August 2022
FL925A
NHTSA #22V-227
Transport Canada #2022-171

Subject: Western Star Hood Side Intake Cover

Models Affected: Specific model years 2020-2023 Western Star 47X, 49X and 57X vehicles manufactured March 19, 2019, through April 1, 2022.

Fig. 8, Drilling Holes into the Air Intake Cover

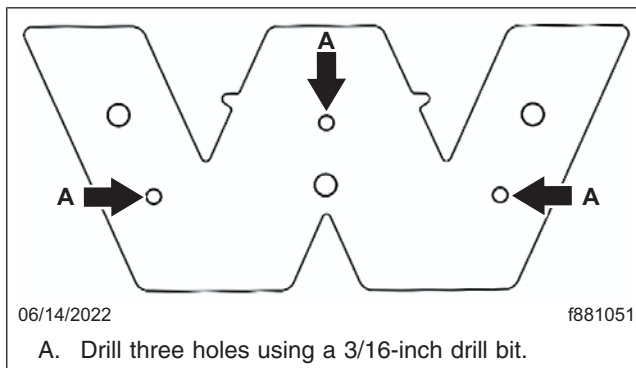
18. Center punch the rivet locations, then use a 3/16-inch drill bit to drill three holes through both the air intake cover and the air intake carrier. See [Fig. 8](#).
19. Deburr the drilled holes on the air intake carrier.
20. Install three rivets into the drilled holes, with washers installed on the air intake carrier side. See [Fig. 9](#).
